SUBJECT: Responds to Confirmatory Item 210, "Isolation of Circuits,"
 per 860502 telcon. Util physically disabled Points Board
 Drawing 430402-001 encl.

May 9, 1986
(NMP2L 0711)

Re: Nine Mile Point Unit 2
Docket No. 50-410

REV	DATE	BY	CHKD	DESCRIPTION
1	10/15/64	W.A. ROSS		SCHEMATIC ANALOG ISOLATION
2	11/2/64	W.A. ROSS		ANALOG ISOLATION
3	11/2/64	W.A. ROSS		ANALOG ISOLATION

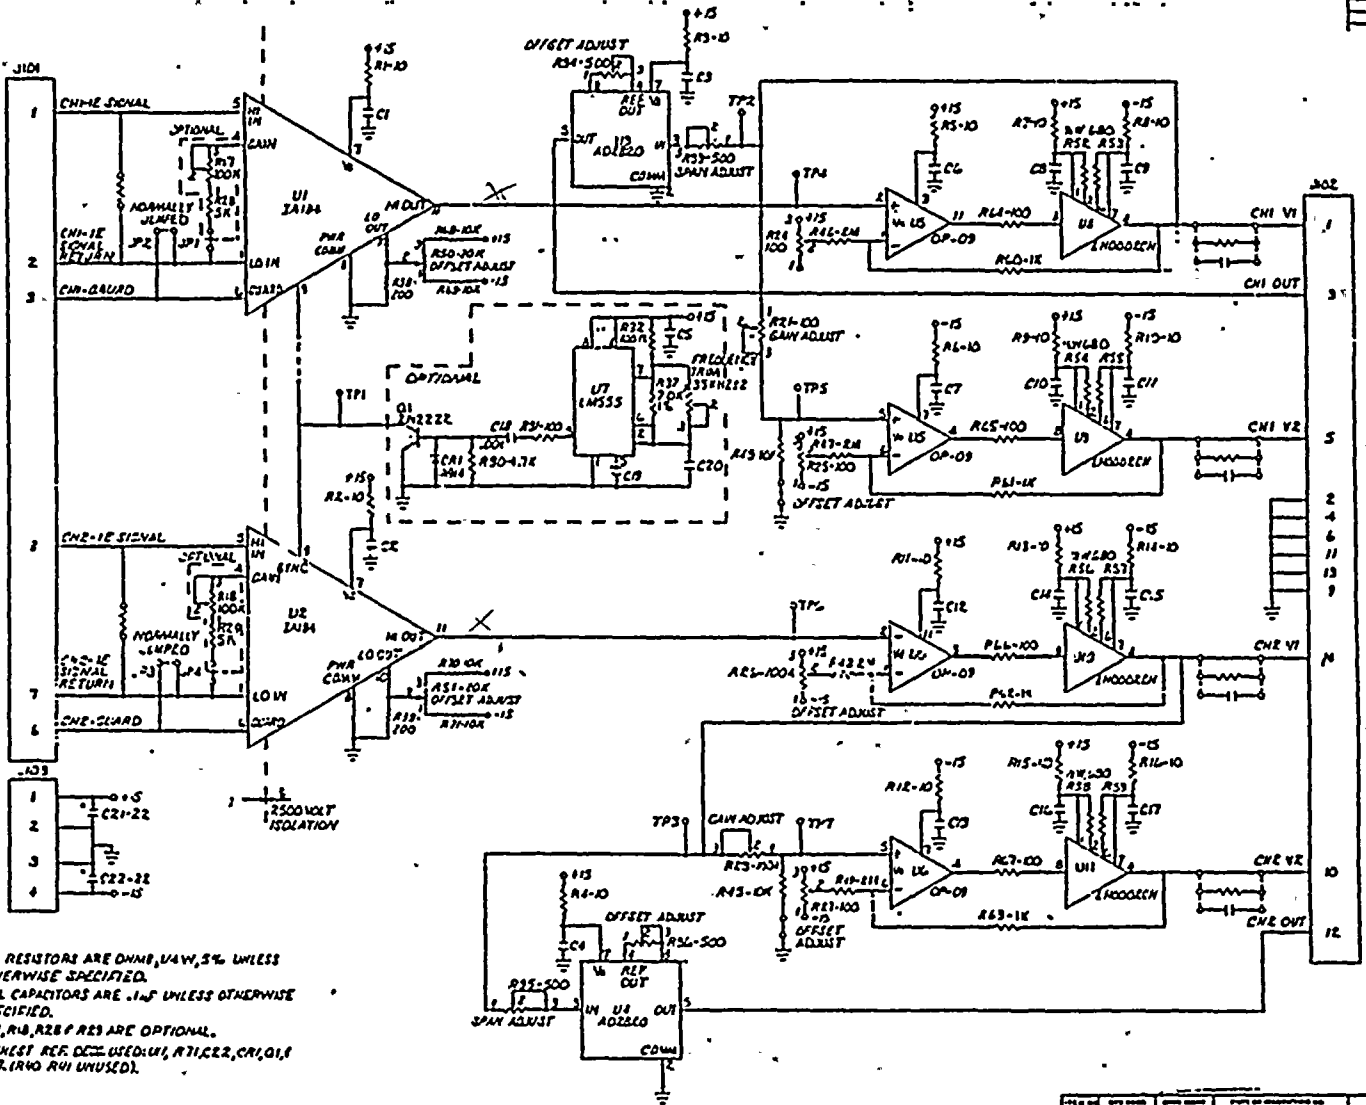
This letter regards a May 2, 1986 telephone conversation with your staff concerning Confirmatory Item 120 "Isolation of Circuits". As a result of that conversation, Niagara Mohawk has decided to physically disable (by removing the pins) points 1, 5, 14 and 10 as shown on Schematic Analog Isolation Board, Drawing No. 430402-001 in the output block J102 (attached). This will ensure that the 0 to 5 VDC and 0 to 10 VDC connections will not be used as a functional connection of the analog isolation module supplied by Kaman. The maximum credible fault voltage was applied to the 4 to 20 MA output point (pin 3) as described in my April 15, 1986 letter and test report. The appropriate documentation will be revised to reflect the nonusage of these other points output.

If the use of these points ever becomes necessary, the maximum credible fault voltage test as described in my April 15, 1986 letter and test report will be performed for the 0 to 5 and 0 to 10 VDC connections described above. The Nuclear Regulatory Commission will be notified of the test results prior to the use of these points.

Our response to Final Safety Analysis Report Question 421.13 will be changed to clarify this modification to the Analog Isolation Module.
